3rd & Cherry

DESIGN REVIEW BOARD RECOMMENDATION MEETING

April 2, 2019

Project Address: **601 4th Avenue**
SDCI Project #: **3028747**

Design Response - Cherry Street Wall

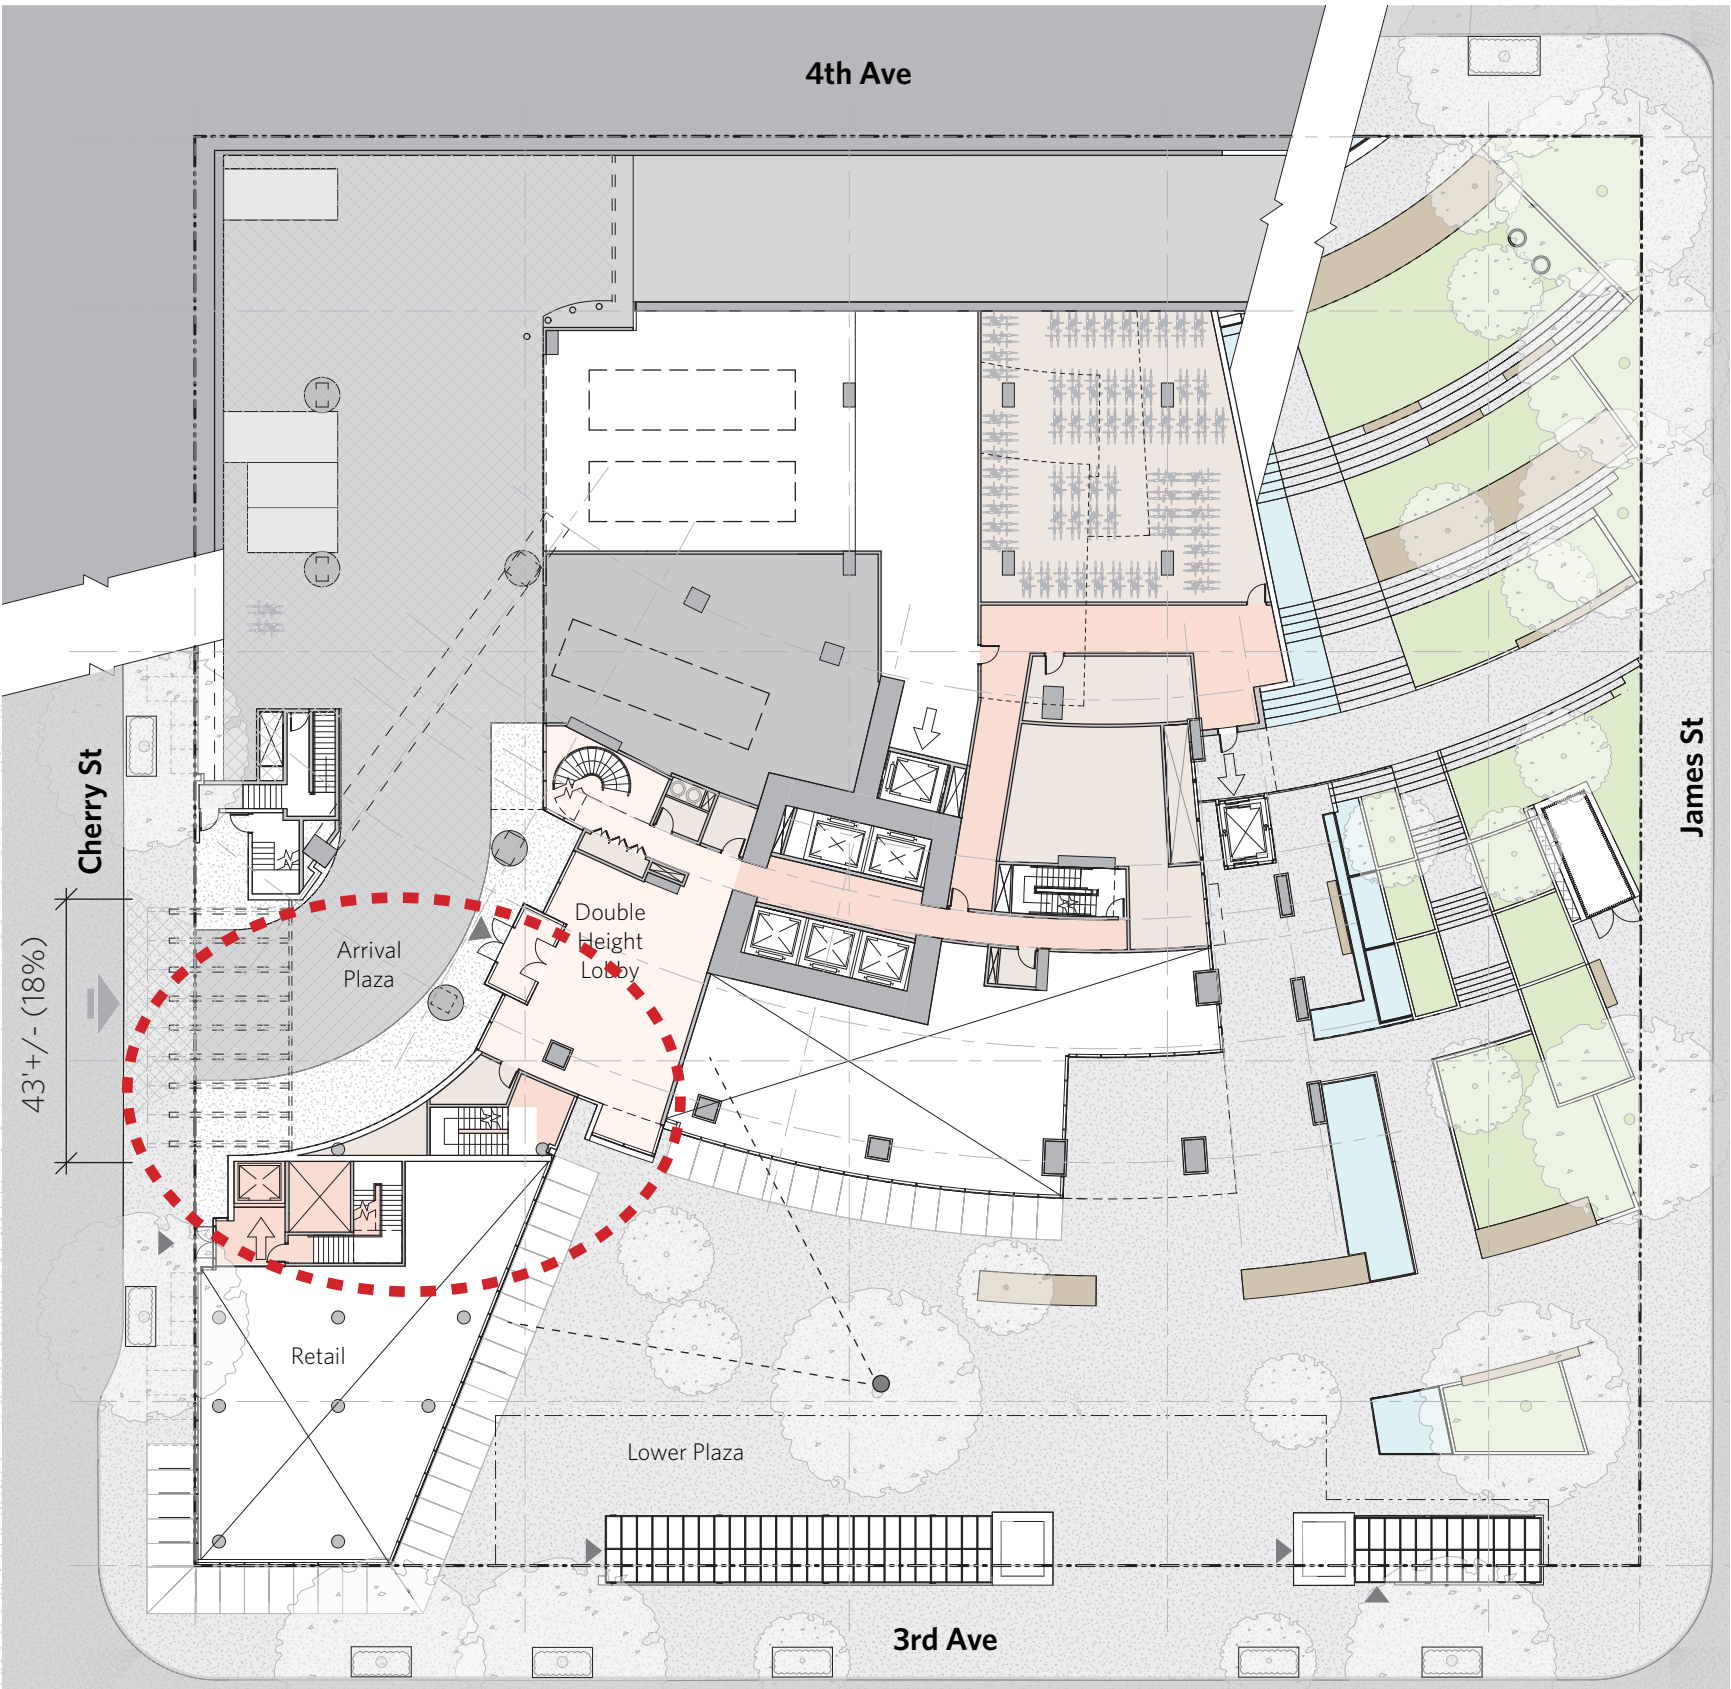
The Board strongly supported the development of the street wall edge along Cherry and the addition of retail to support the heavily used pedestrian route. To avoid the presence of blank concrete walls, the Board recommended stepping the retail frontage and expanding the transparency down to the pedestrian. (B1, C1, C3)

Upon further consideration of the sites surrounding context, and challenges posed by the pass-through route, the concept of a pass-through was abandoned. As Cherry Street is lined by historic buildings with strong street wall presence, the project now responds to this by reinforcing the street wall. Additional retail provides animation, light and activation along this predominant street edge.

Design Response - Site Plan

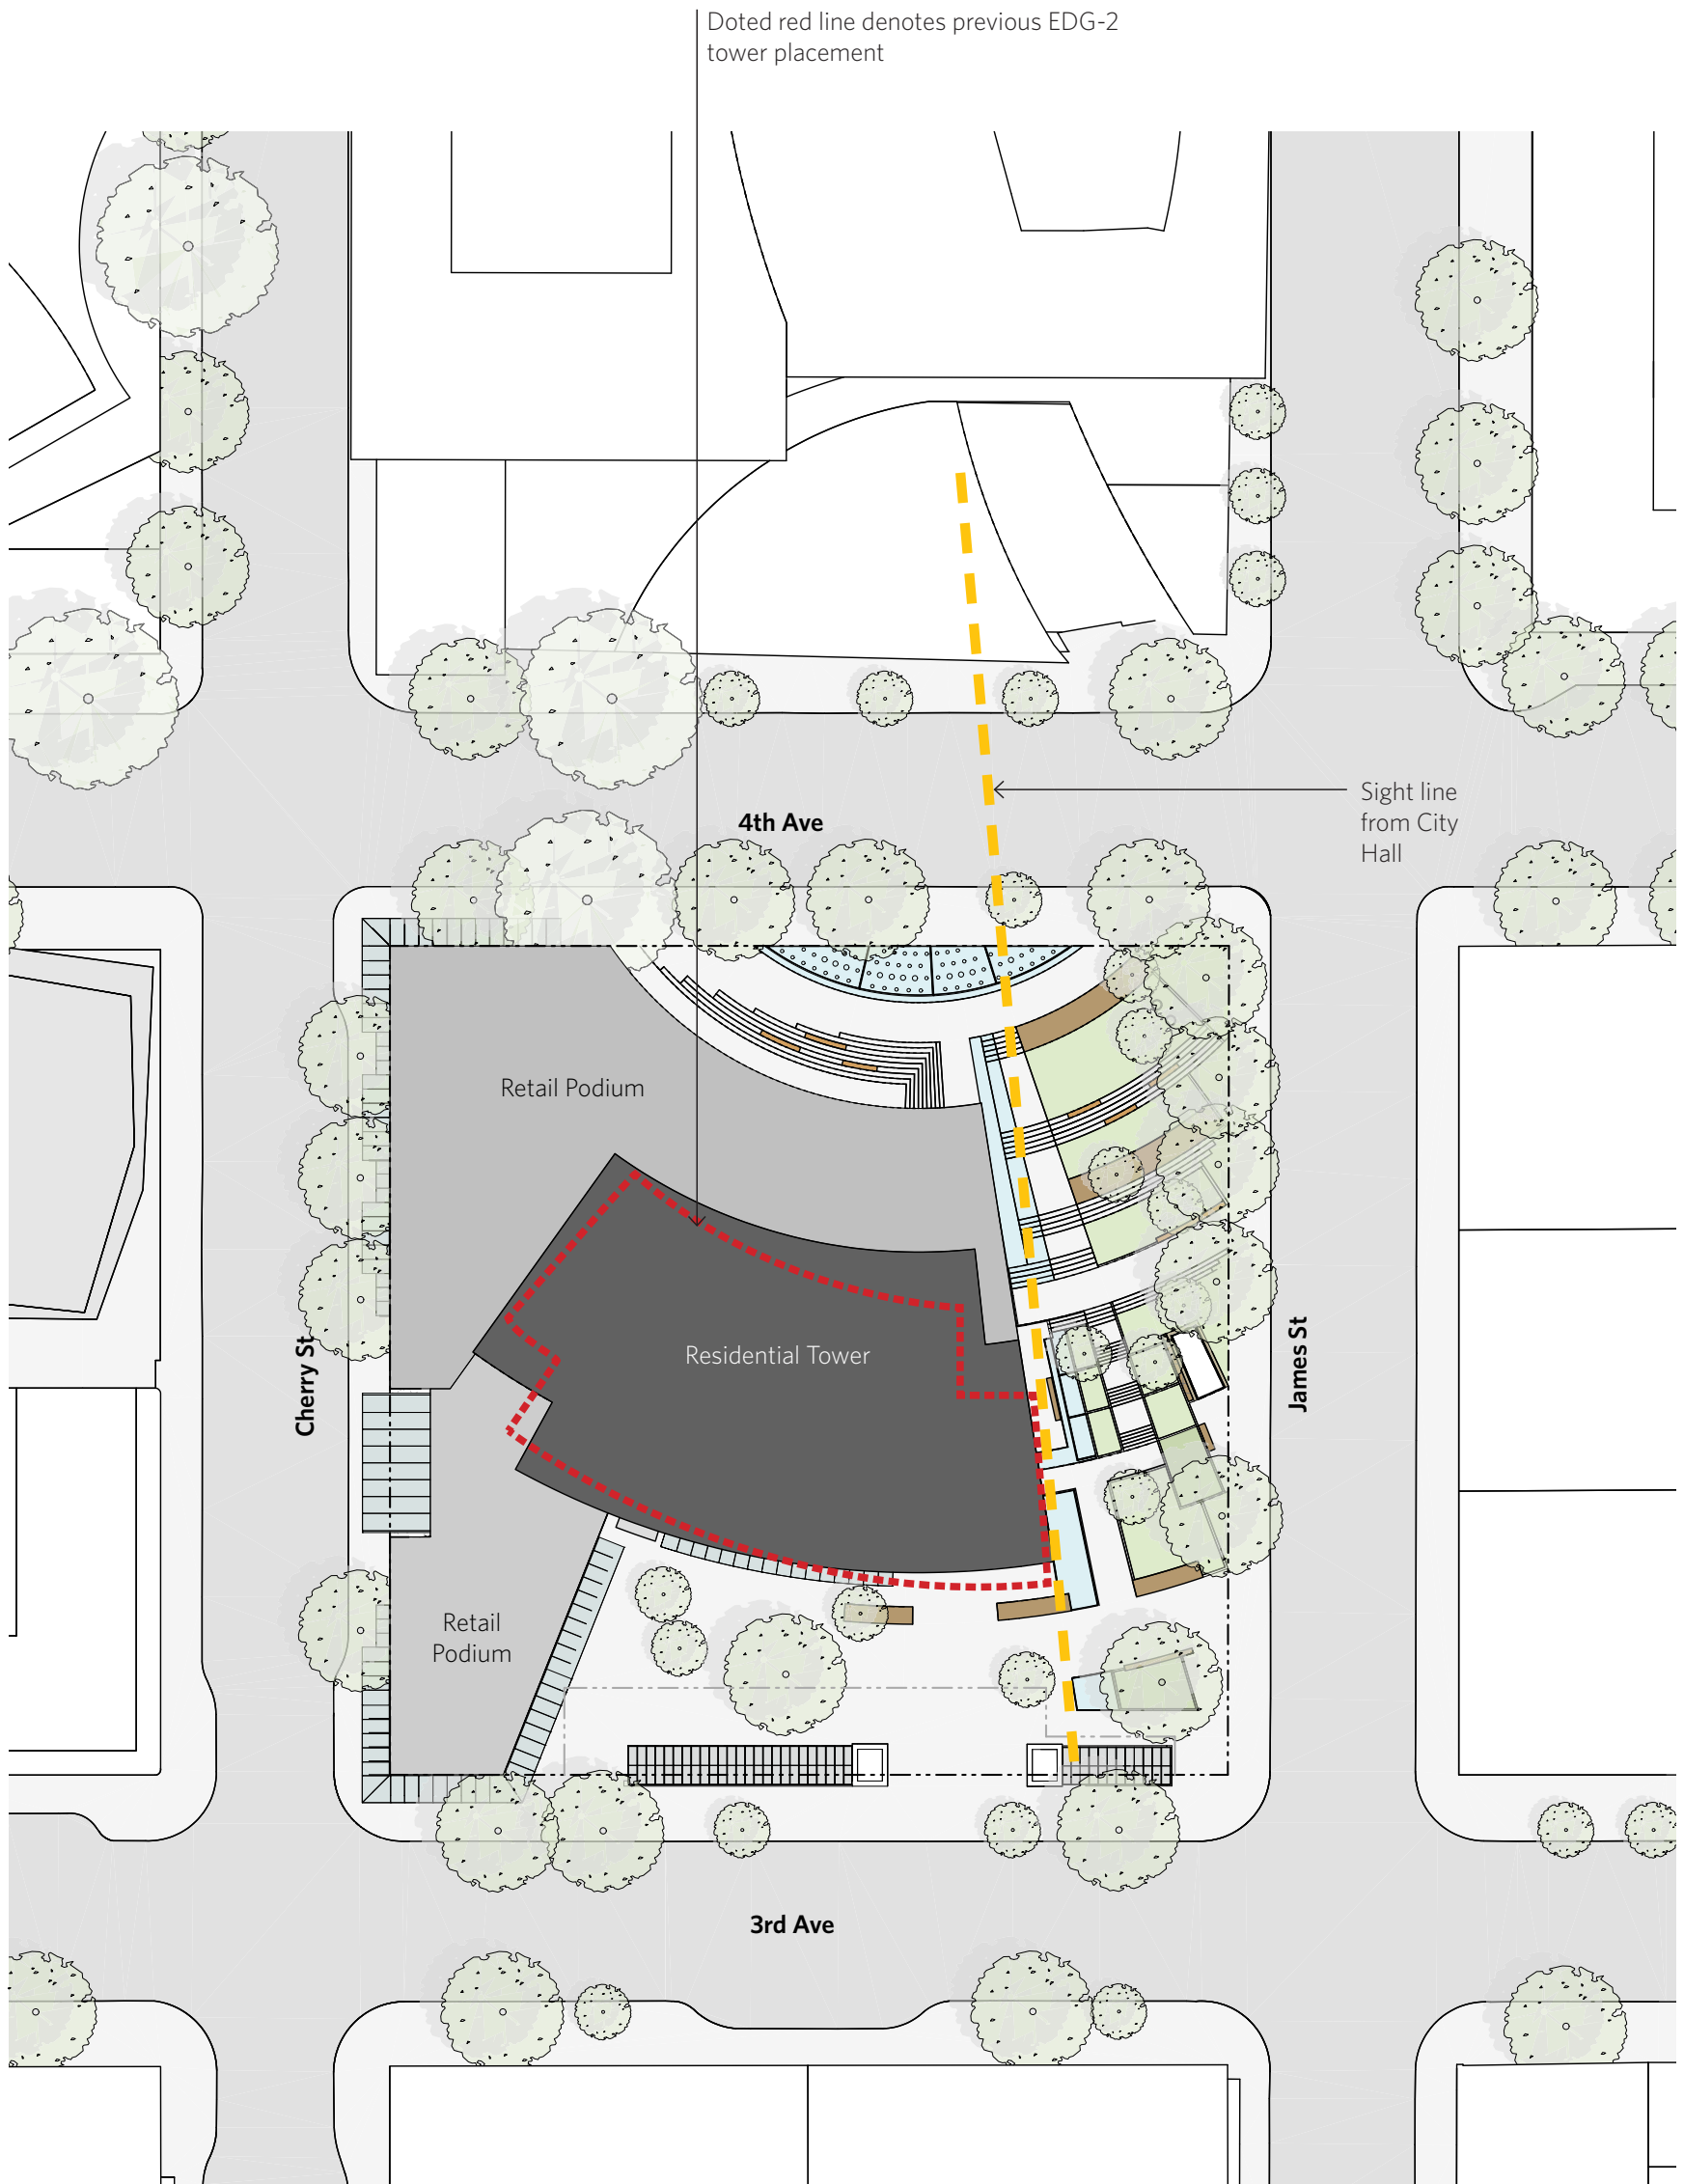
While the majority of the Board supported the location of massing on the site and the general intent to create a series of open spaces, the Board unanimously agreed they would be open to rotating or shifting the tower form further northeast, closer to the corner of 4th and Cherry to provide additional room for the open space and expand visual connection through the site. (A1, B1, B3, D1, D3)

The tower has been slightly rotated and shifted further northeast from the scheme presented at EDG 2. This allows additional area in the lower plaza, while maintaining views through the site from Fourth Avenue to Third Avenue.

Design Response - View of Water Feature

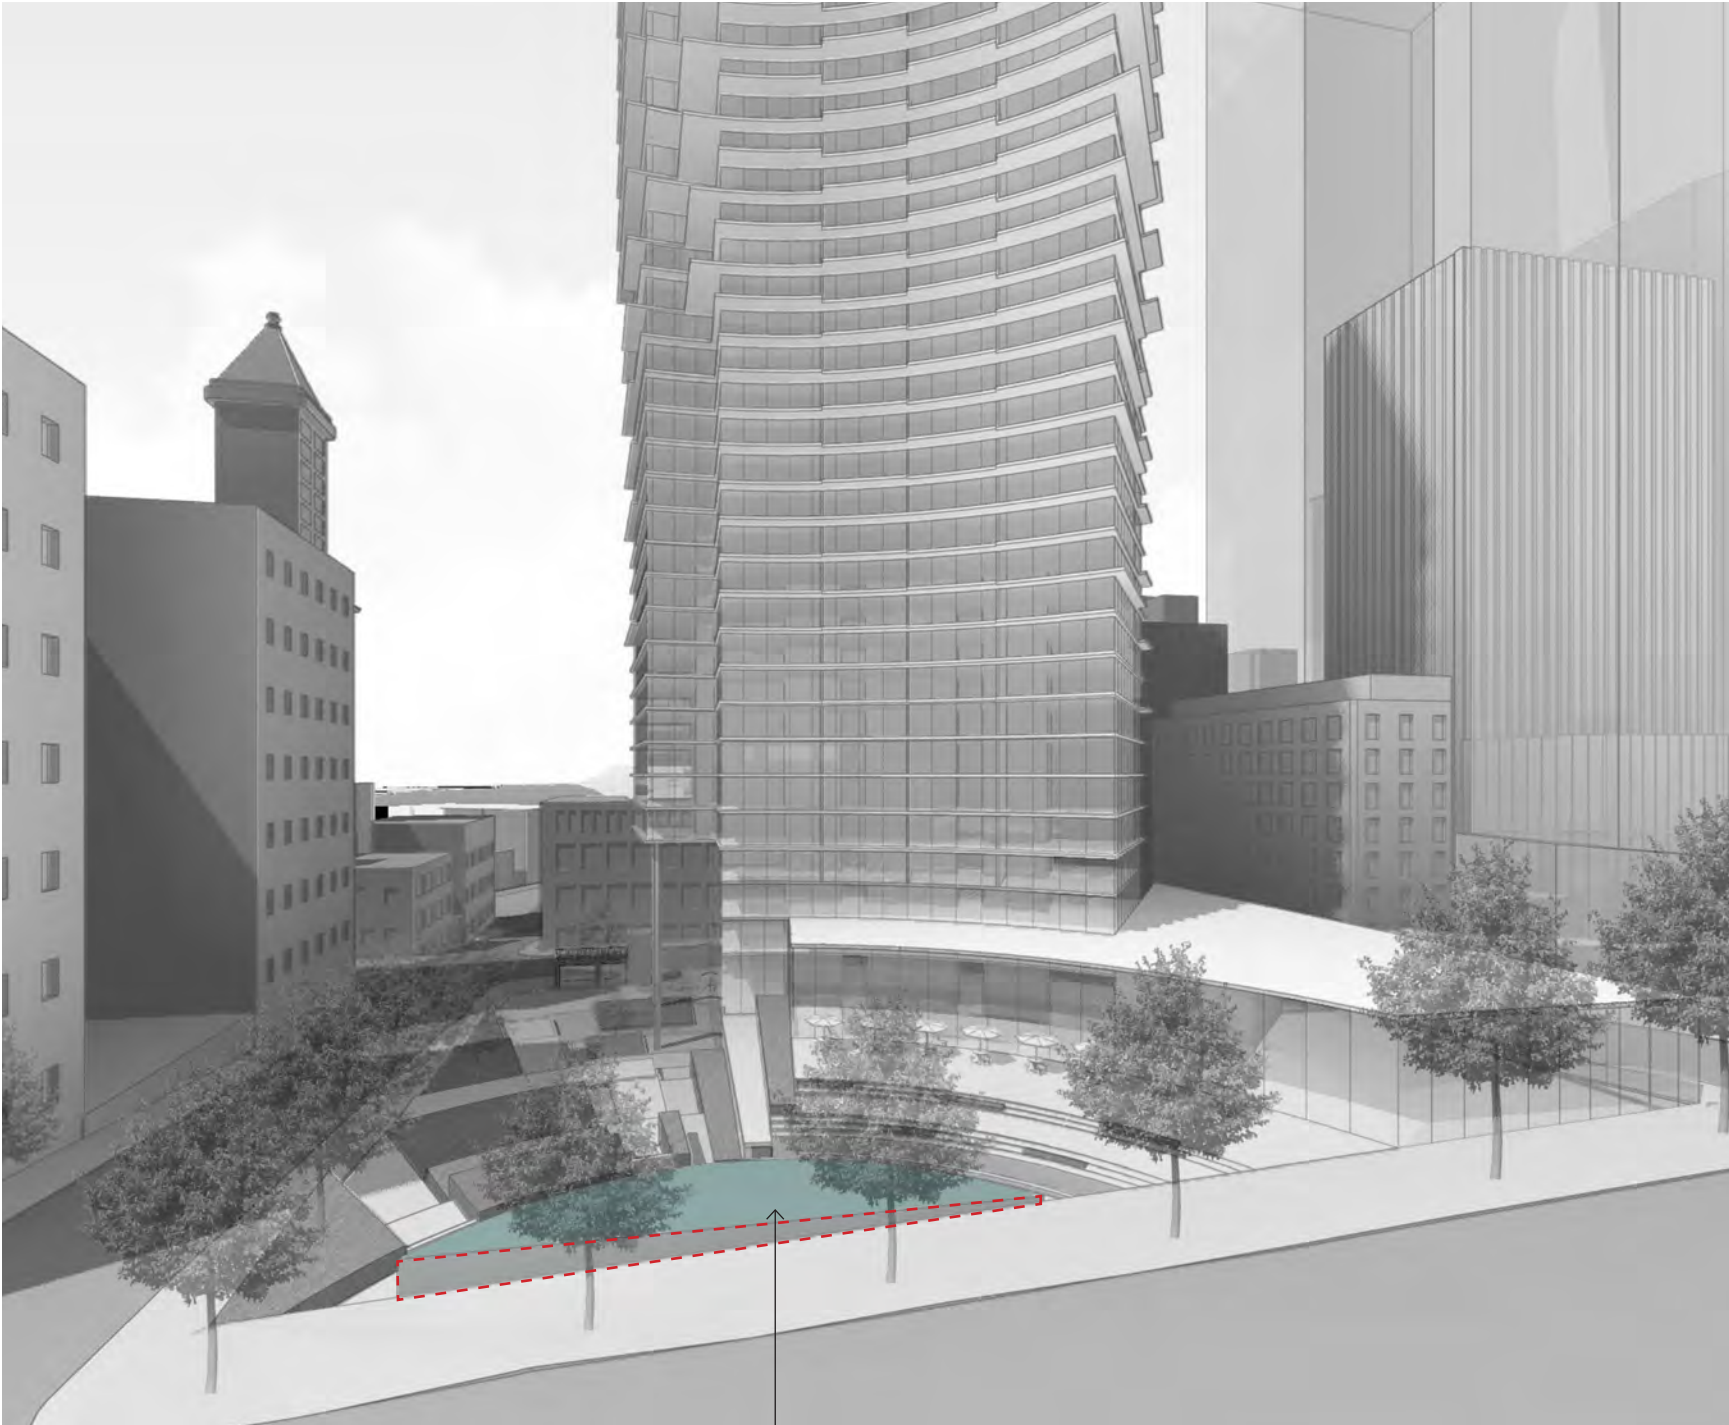
While the Board supported the design intent to create a series of open spaces allowing for varied experiences, the Board agreed with public comment that additional design development was needed to ensure the open spaces feel welcoming to the public and gave guidance to enhance accessibility and connectivity.

The Board supported the effort to create a visual connection between the upper plaza open space provided on site with the City Hall open space as the circular geometry visually joins the spaces together. Related to this open space, the Board was concerned that the circular water feature creates a barrier and recommended refining the height and location to enhance the connection to the street. (A1, B1, B3, C1, D1, D3)

In order to enhance the visual connection between the upper plaza open space with City Hall, the water feature has been lowered and stepped. Furthermore, this water feature is a fountain with jets, which will act as a feature rather than a barrier on the site.

Please note that a residential entrance has also been added beyond the fountain to further animate this open space.
